Rezoning Request – The Central District (Extension) Outline Zoning Plan No. S/H24/6

Proposals to Amend the Outline Zoning Plan to Reduce the Amount of Reclamation, Reduce the Amount of Commercial Development and Reduce the Extent of Roads

Volume 1
Planning Statement

保護海港協會有限公司
Society For Protection Of The Harbour Ltd

FIGURE 13 Proposed New Outline Zoning Plan

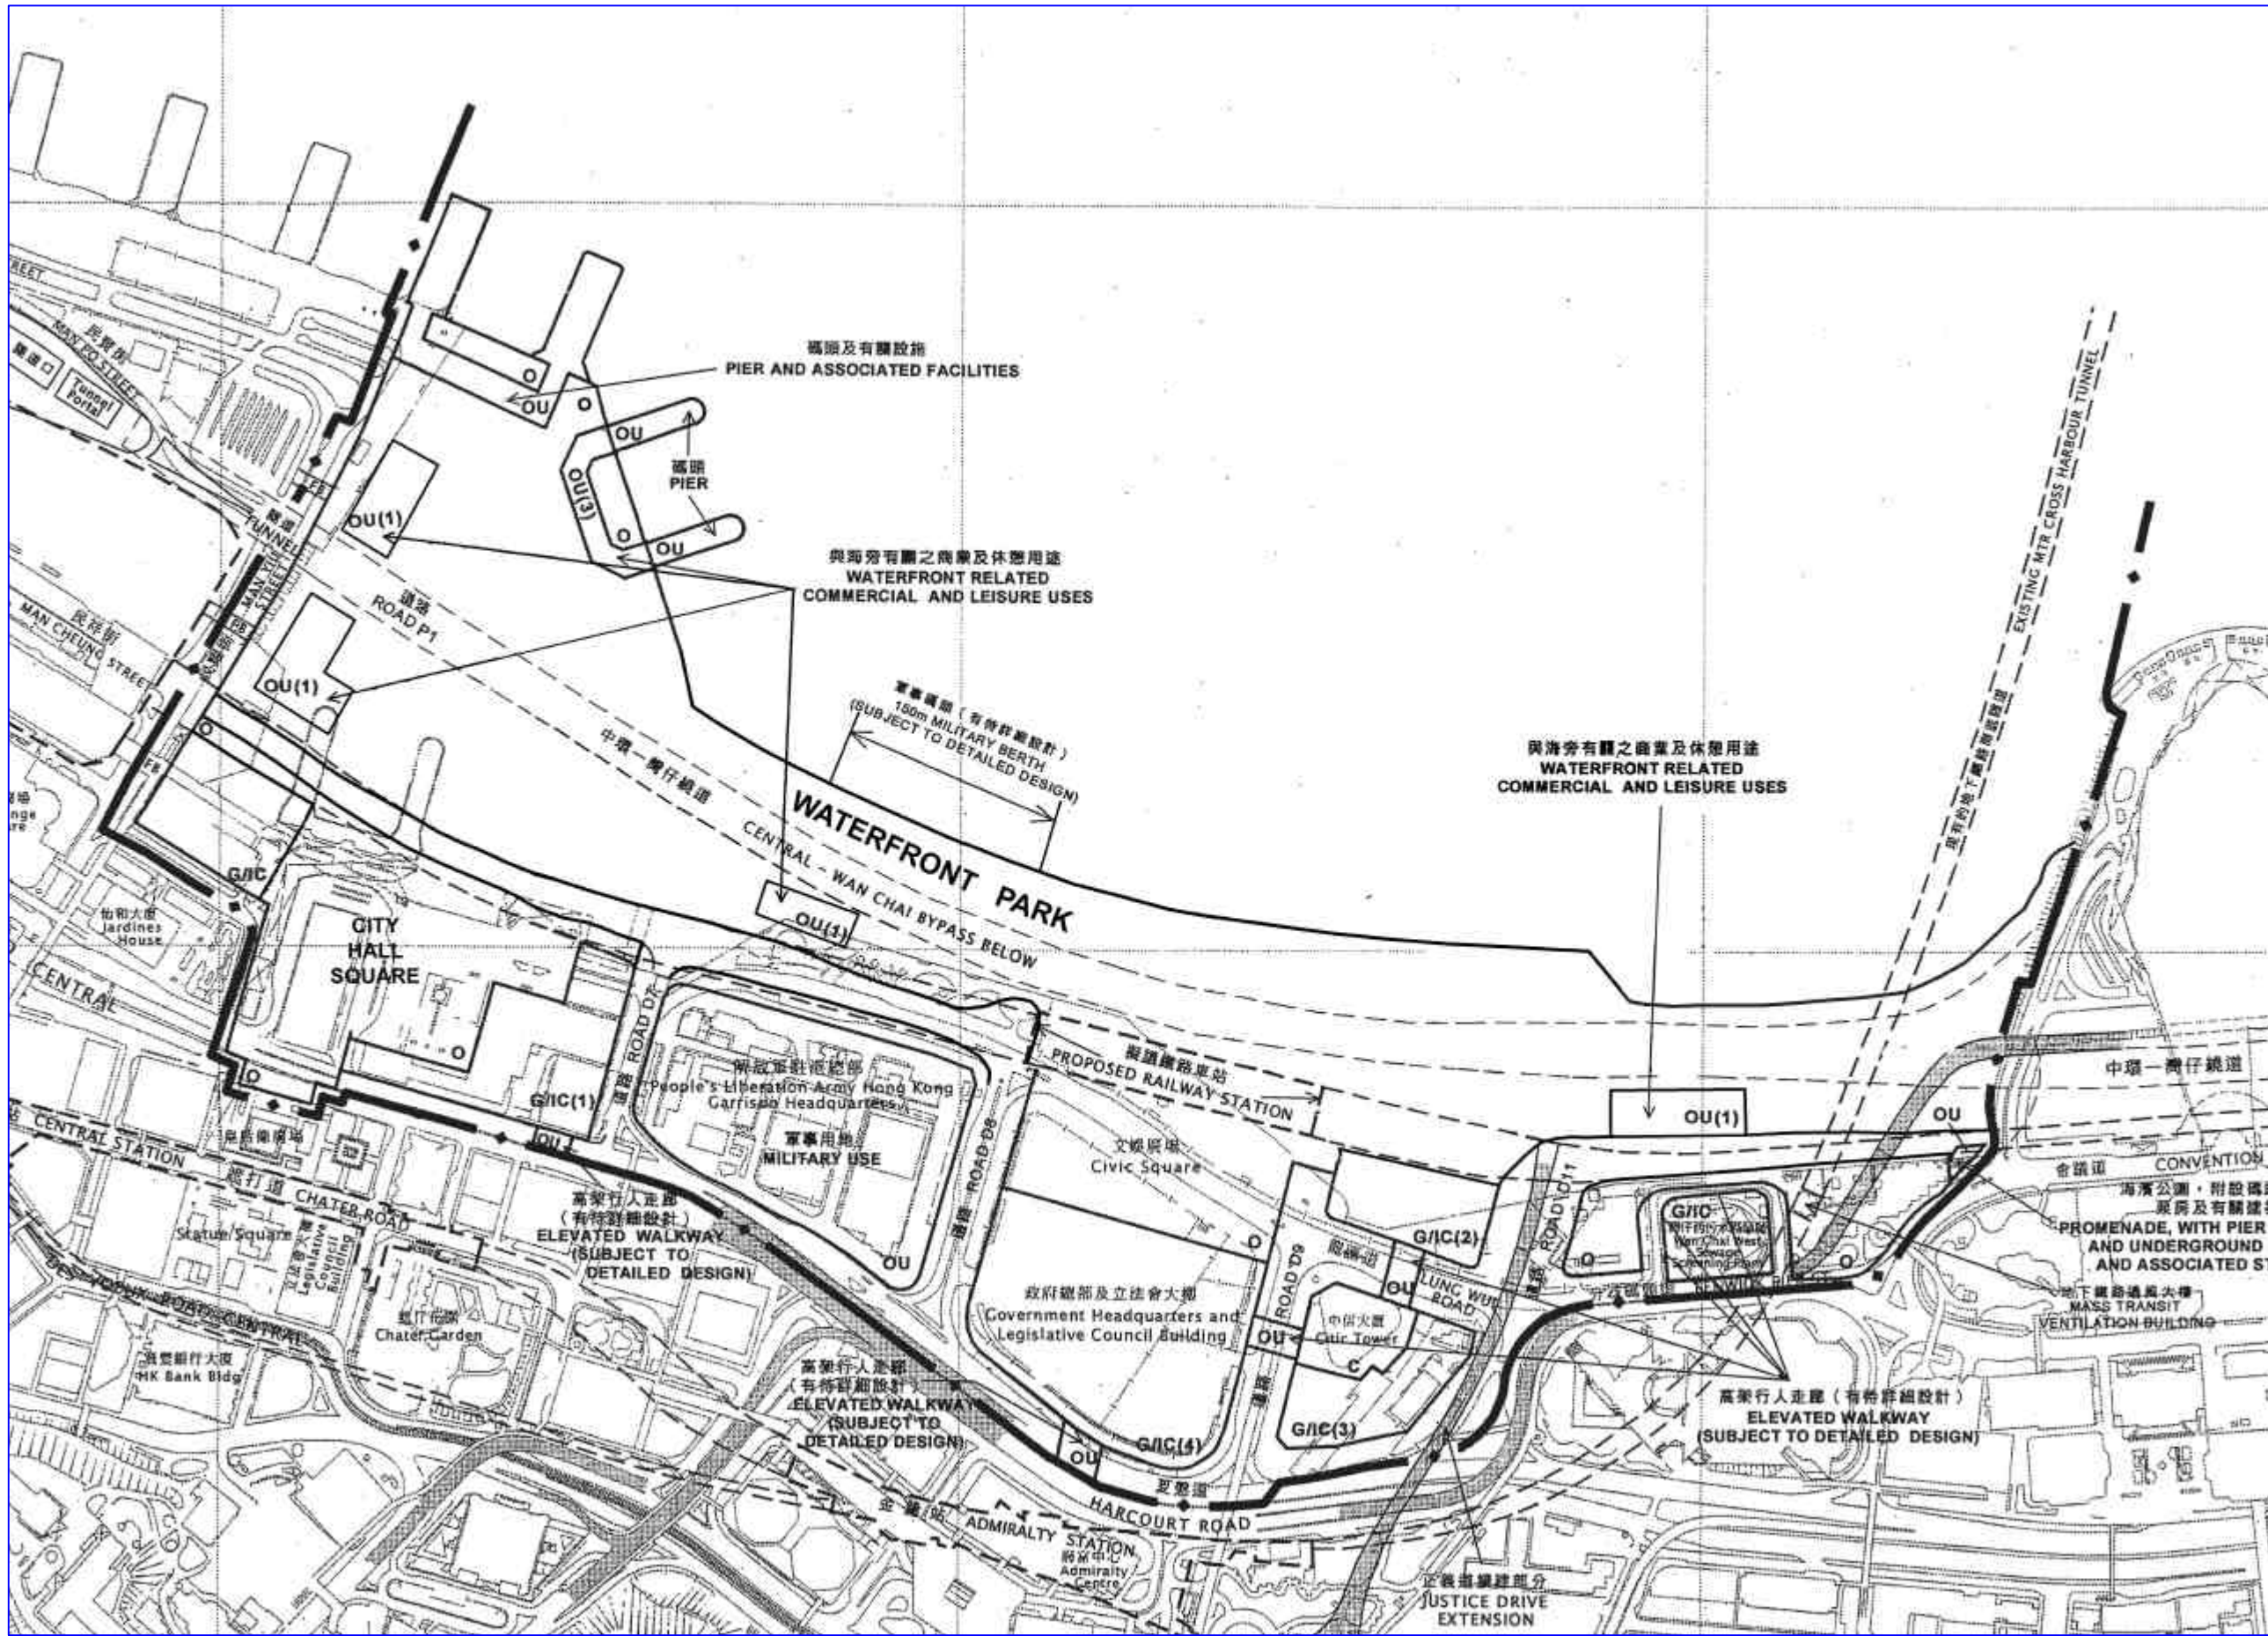
Figure 13 is a plan which consolidates all of the changes into one new plan which is proposed as the amended plan for consideration by the Board.
